THM 4L80-E NEW TEMP SENSOR

Figure 1

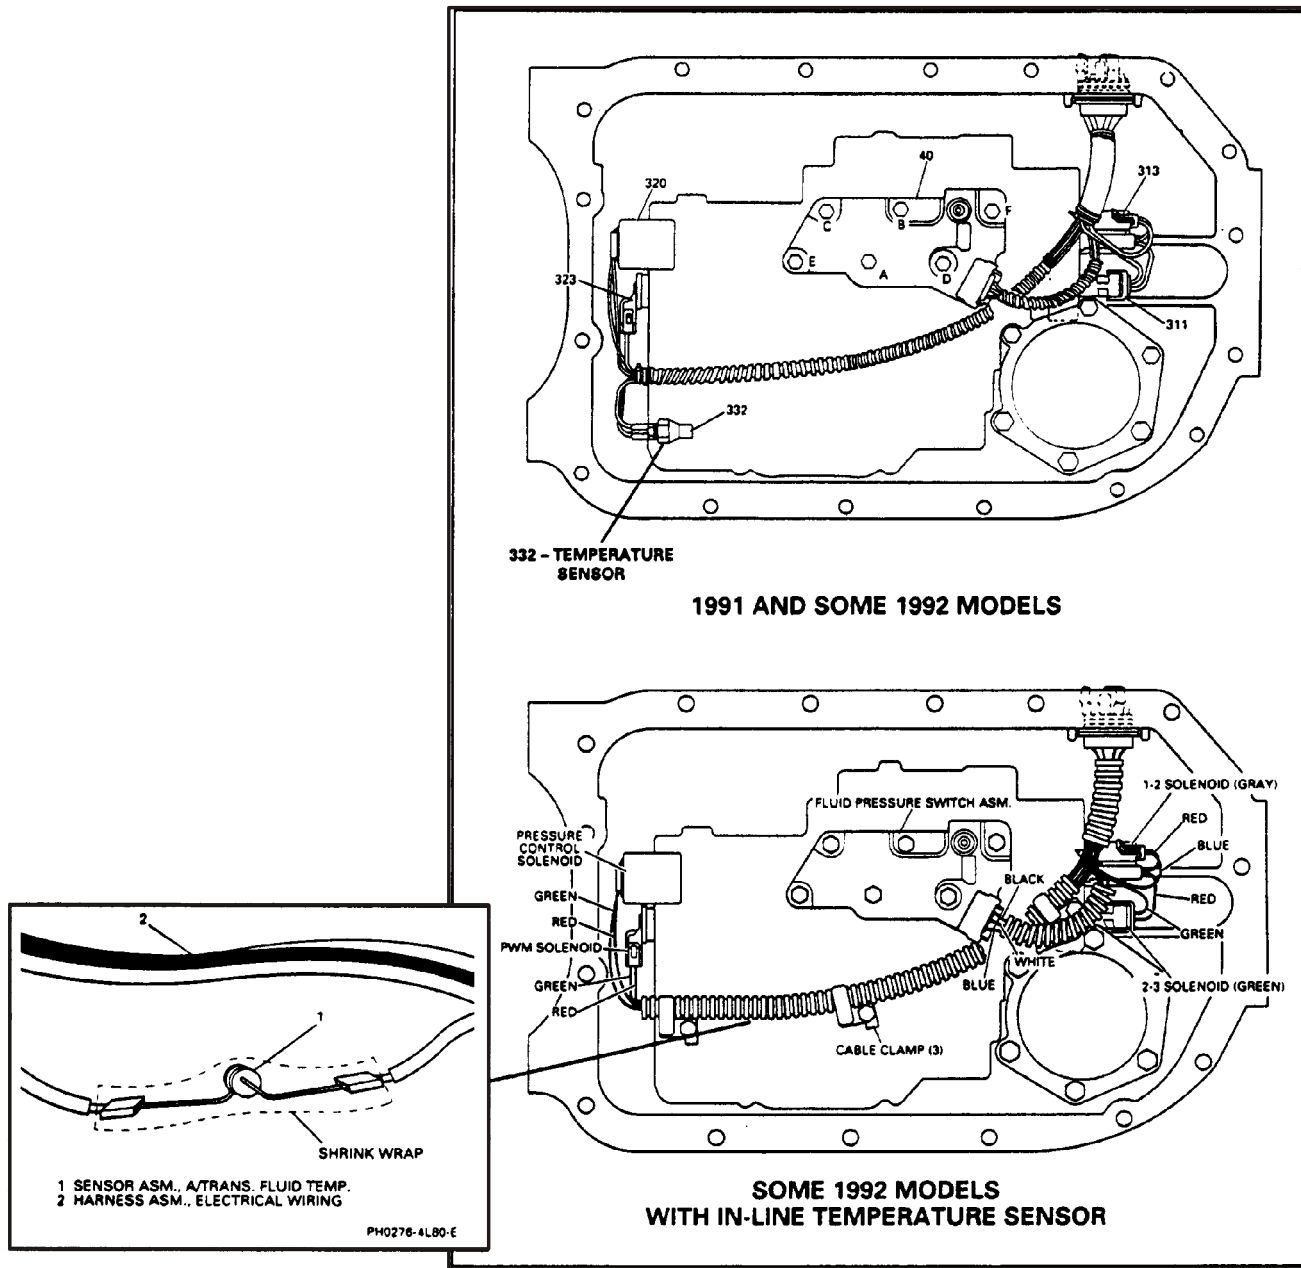
Some 1992 model THM 4L80-E/4L80-EHD transmissions are now equipped with a new Transmission Oil Temperature (TOT) sensor incorporated within the transmission wiring harness as shown in Figure 1, and replaces the TOT sensor that screwed into the valve body on previous models.
